SMYRNA SCHOOL DISTRICT Smyrna Elementary School Renovations and Addition Bid Number SSD-15-001

ADDENDUM NO. 5	7 April 2015
	Smyrna School District Smyrna Elementary School 121 South School Lane Smyrna, Delaware 19977
	Fearn-Clendaniel Architects, Inc. 6 Larch Avenue Suite 398 Wilmington, Delaware, 19804 Phone: (302) 998-7615 Fax: ((302) 998-7685
BIDS DUE:	3:00 p.m. on April 13, 2015
LOCATION:	Smyrna School District Administrative Offices 82 Monrovia Ave, Smyrna, DE 19977

ARCHITECT'S PROJECT NO: 14107a

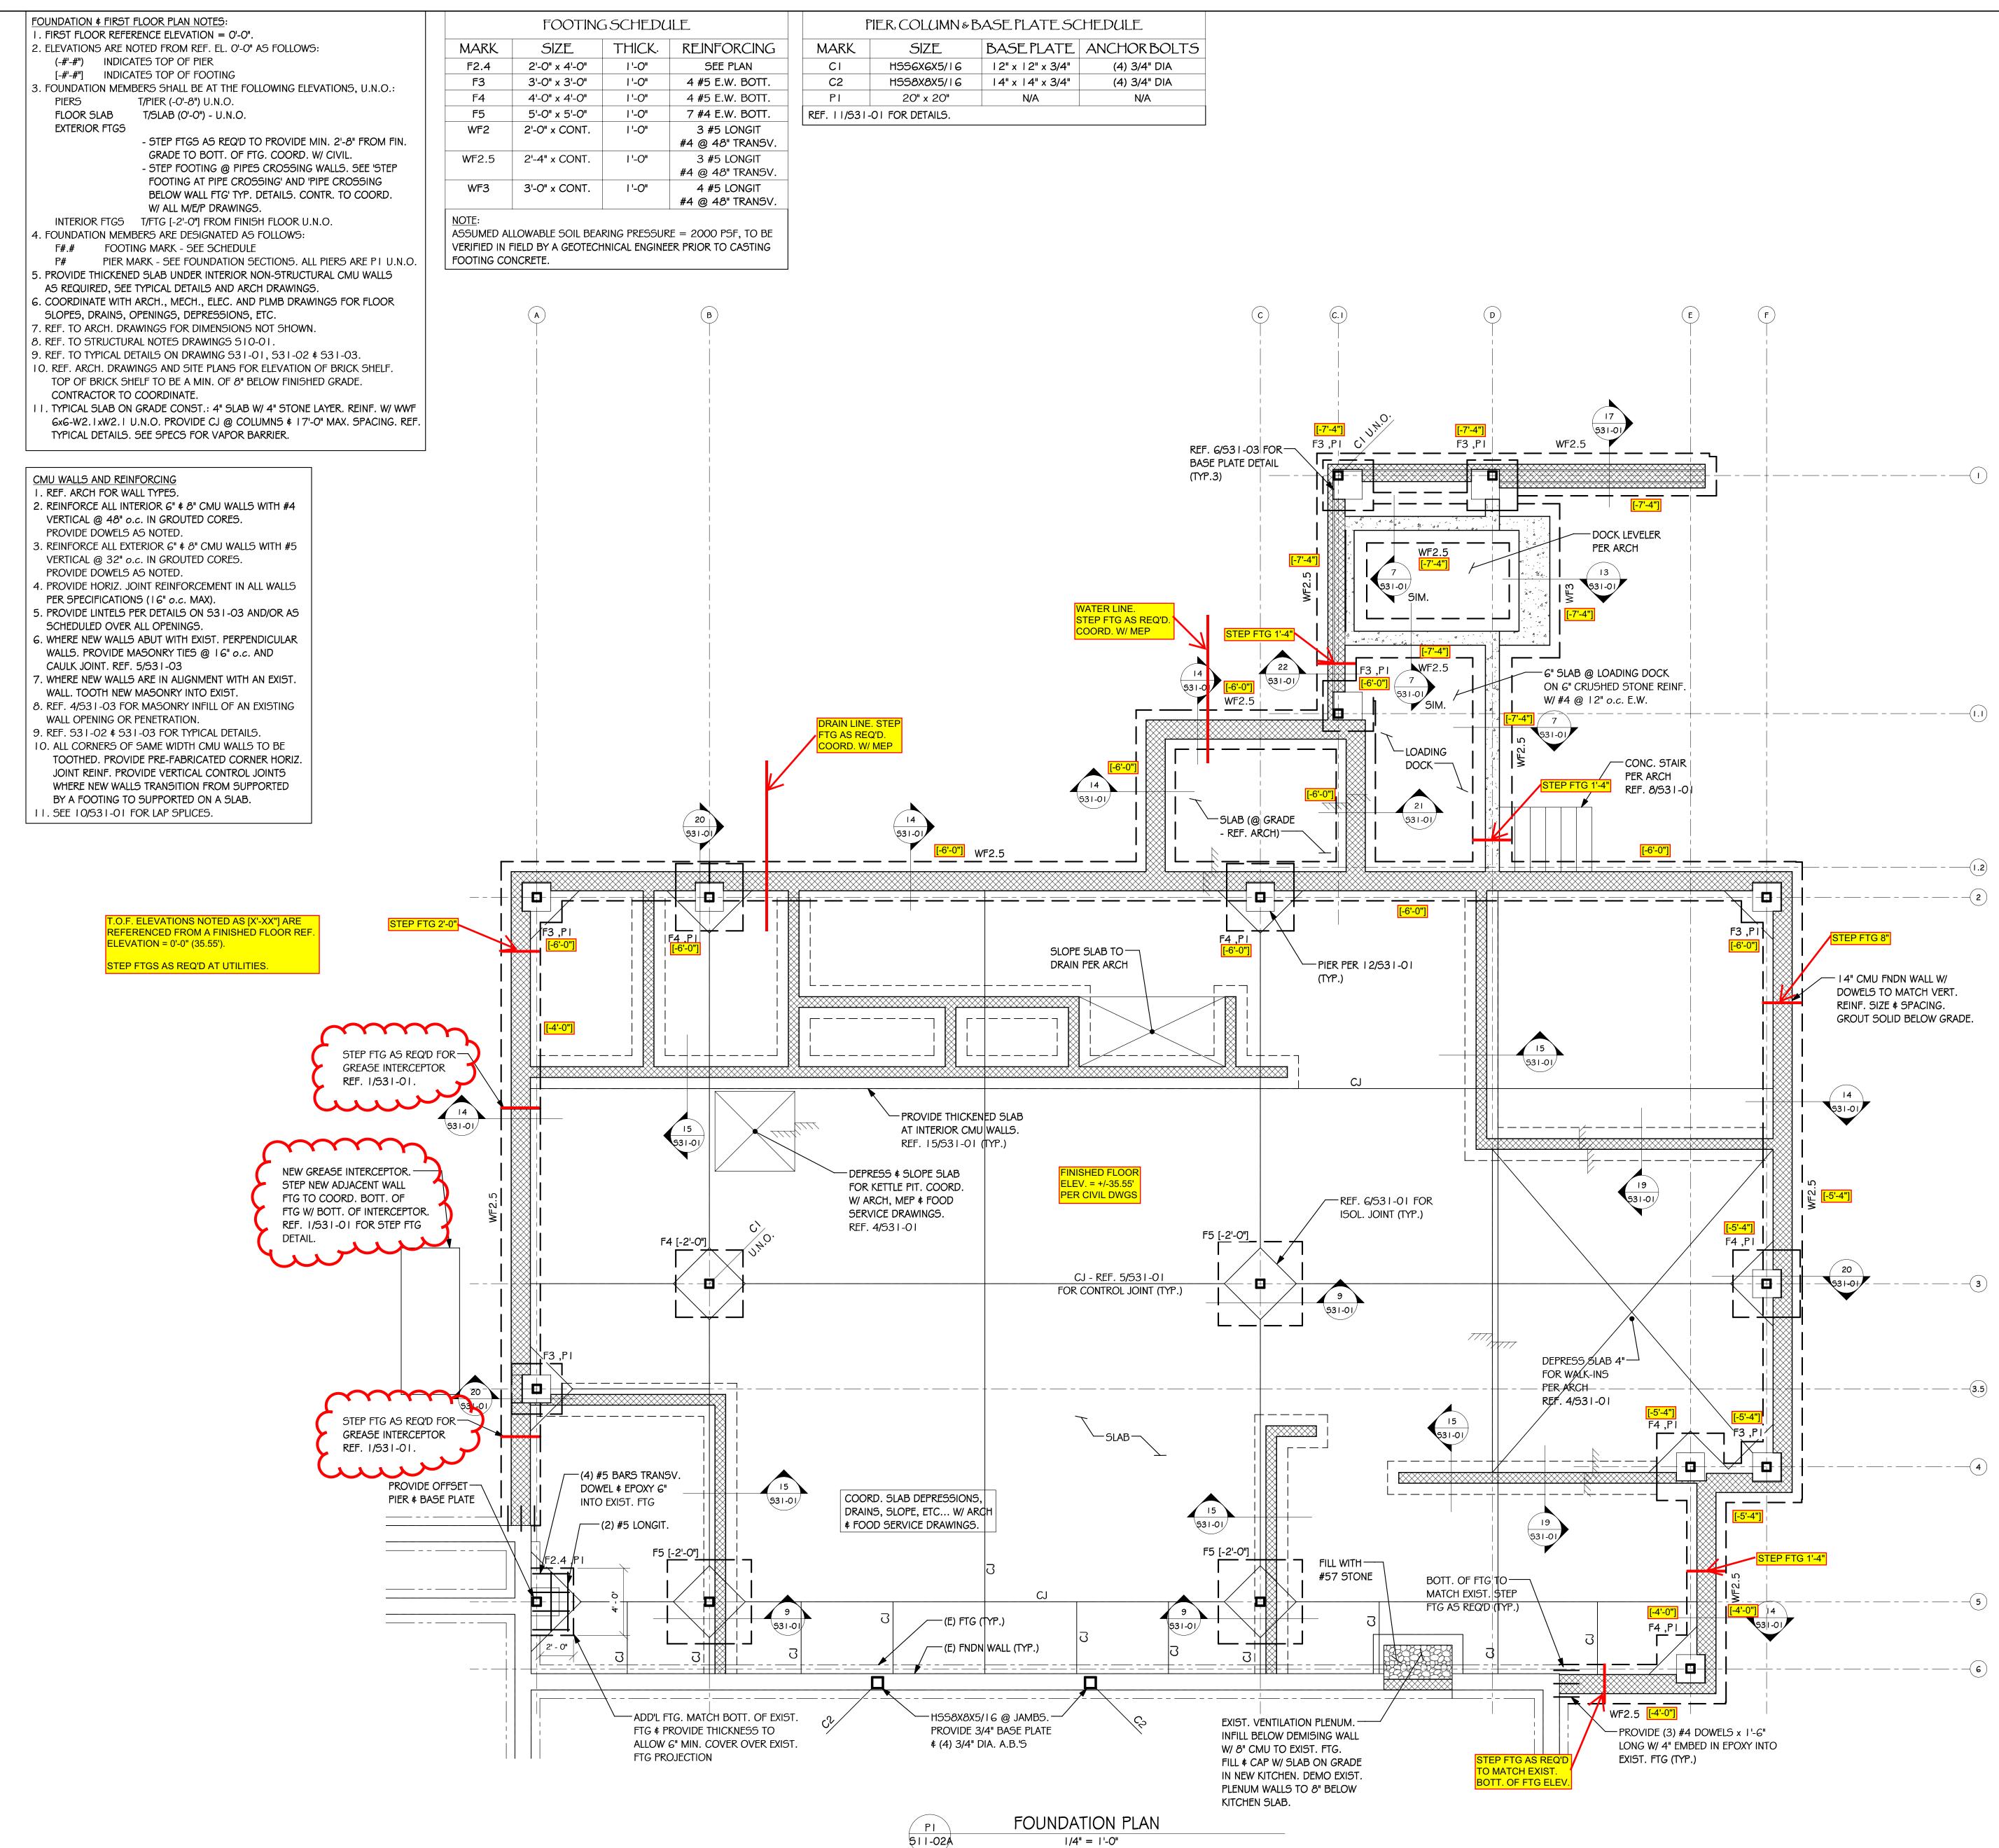
2.10 **Q:** Addendum #2 added notes 8 and 9 to drawing E12-02. Please confirm that these two notes apply to room 143.

A: Yes, notes 8 and 9 apply to Room 143.

PIER, COLUMN & BASE PLATE SCHEDULE						
MARK	SIZE	BASEPLATE	ANCHORBOLTS			
CI	HSS6X6X5/16	2" x 2" x 3/4"	(4) 3/4" DIA			
C2	HSS8X8X5/16	4" x 4" x 3/4"	(4) 3/4" DIA			
PI	20" x 20"	N/A	N/A			
REF. 11/531-	EF. 11/531-01 FOR DETAILS.

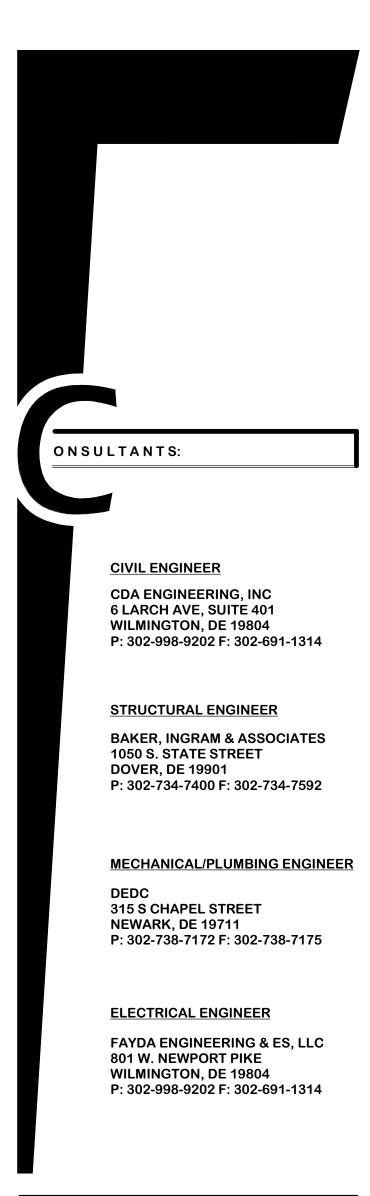
2.6 **Q:** A clarification was requested for Item 2.19, Addendum 4: Foundation Footings

A: GC is responsible to coordinate bottom of footing with grades indicated on civil drawings and utility lines intersecting wall below grade. For clarification, see attached S11-03 drawing with TOF elevations. Step footing as required.
